Re: Barnes Nursery, Inc.

NOTICE OF APPEAL

ODNR has completed its formal consistency review of your proposed project (Corps public notice number 2000-02170(1)). Your proposed project area is located in the designated Coastal Area of Lake Erie. The Ohio Coastal Management Program (OCMP), approved by the U.S. Department of Commerce (National Oceanic and Atmospheric Administration), requires that any project that is situated in the Coastal Area be consistent with the policies of the OCMP. Pursuant to 16 U.S.C. 1456 (c) (3); 15 C.F.R. 930.64(b), Ohio objects to the consistency certification for this project based on enforceable policies.

**LAKE ERIE WATER LEVELS, 1860-2001**  
(from NOAA data)

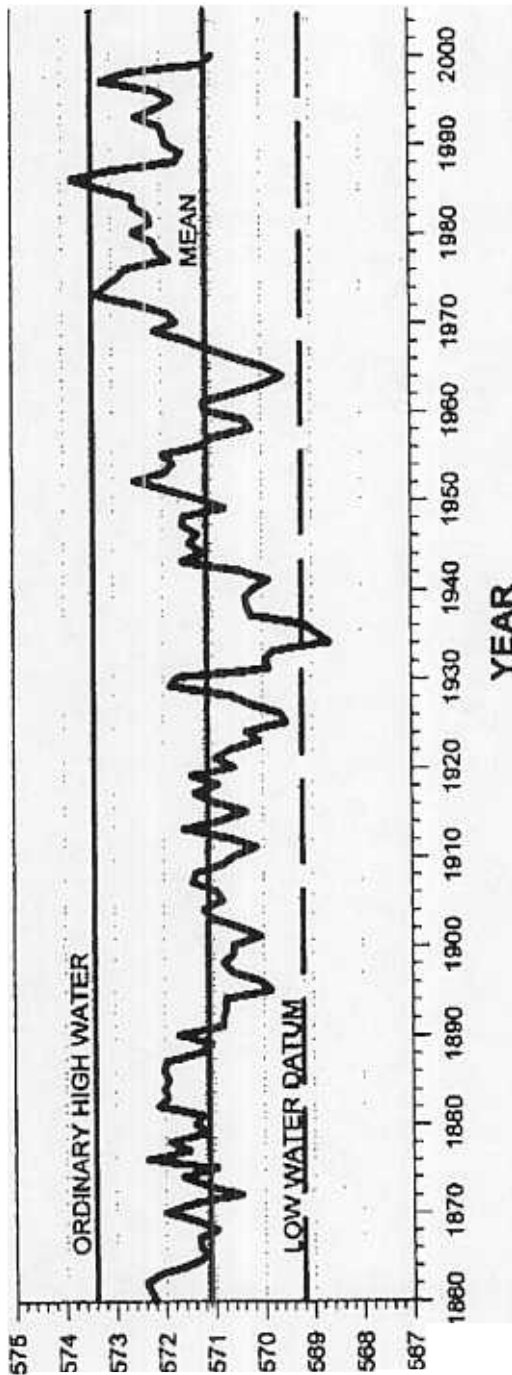
Your letter states that Figure D shows a "channel system visible on 1937 aerial photographs" (page 3, line 9). However, the Figure D with your letter is a graph of "LAKE ERIE WATER LEVELS, 1860-2001." None of the figures in your packet contain a 1937 label.

# Known Cultural Resources - Erie County

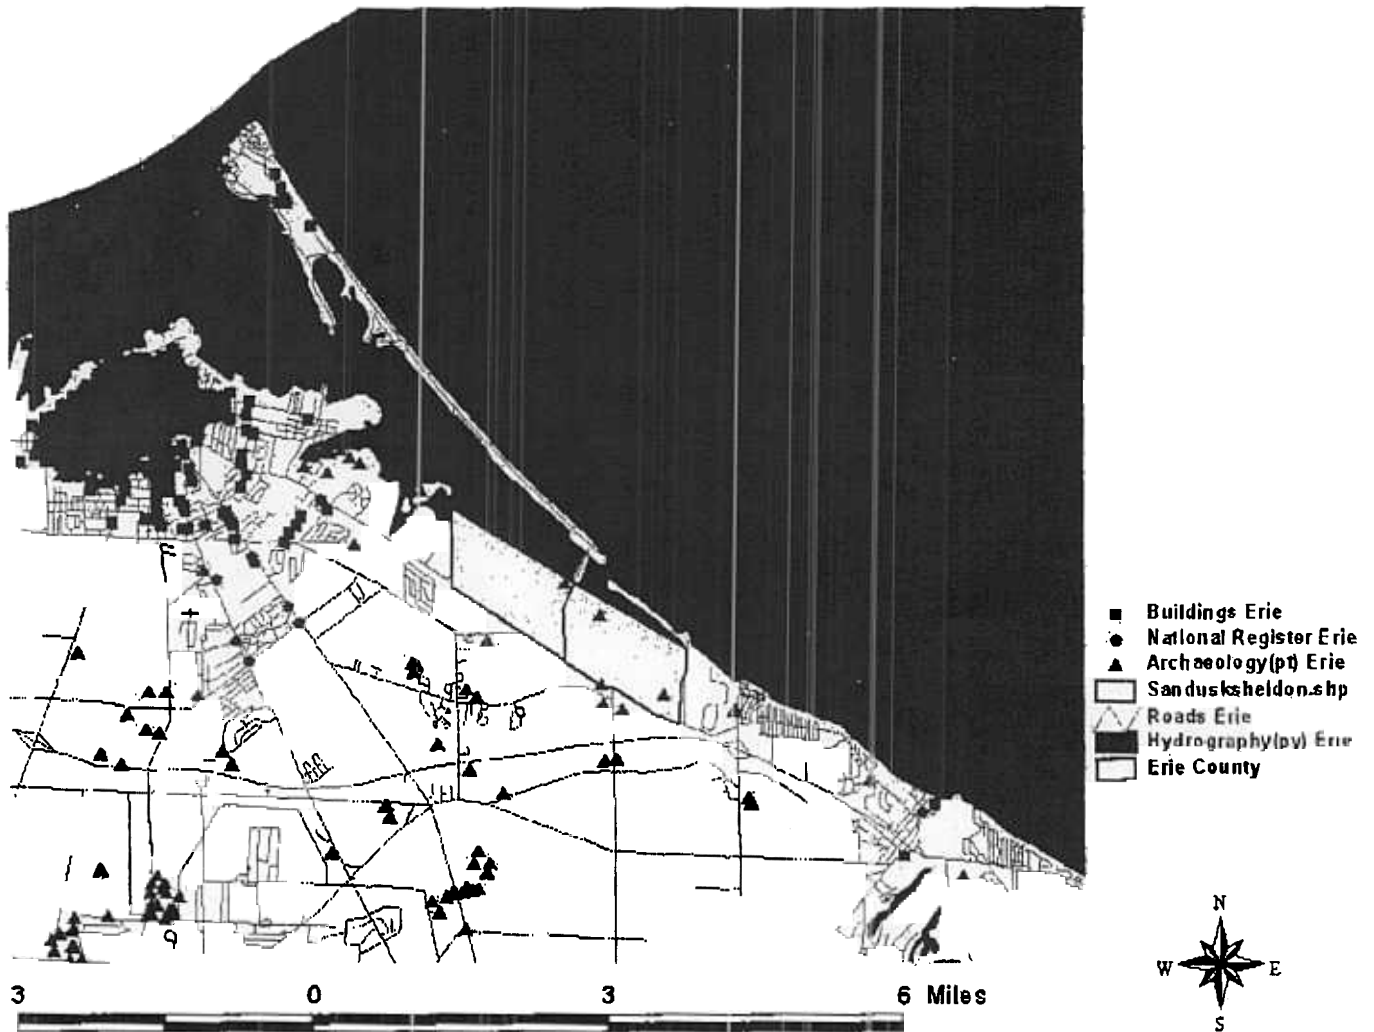
Attached is a figure indicating known cultural resources from Erie County. It appears that the project will damage a known archaeological site (late Archaic period). No information in the form of photographs, graphics or phase I archaeological survey has been submitted to the Ohio Historic Preservation Office. This information is required for the Ohio Historic Preservation to adequately evaluate and offer mitigation advice on significant cultural resources on site.

Archaeological Site. Figure G, attached with your letter shows an archaeological site in the vicinity of our project. This site, 33-ER-436 is located to the south and west of our project. The site produced only one artifact — a slate, notched, butterfly bannerstone. The artifact was recovered during a survey of the site in September 1986. A preliminary documentation form for the site, prepared by Mr. Eugene Edwards and Dr. Jonathan E. Bowen, was received by the Ohio Historic Preservation Office on May 25, 1994. Mr. Edwards was contacted by Barnes Nursery on June 21, 2001 to inquire as to the specific location of the site and any other archaeological information that he could make available. Mr. Edwards visited our project site on June 22, 2001 and conducted a survey of the island and surrounding area. A report of his findings was submitted to the Ohio Historic Preservation Office on June 29, 2001.

In summary, site 33-ER-436 is located on upland property south of our project (the exact location of site is shown on an aerial photograph contained in Mr. Edwards' report, but not included herein in order to preserve the integrity and security of the site). His survey of the island and environs yielded no specific artifacts, only a few pieces of broken flint. No artifacts other than the bannerstone have been found at site 33-ER-436, although Mr. Edwards has surveyed the site on several occasions. He concluded that our project does not adversely impact site 33-ER-436 or any other archaeological site. He believes that the construction of our project may help protect site 33-ER-436 from destruction by the rapidly receding south shore of Sandusky Bay.
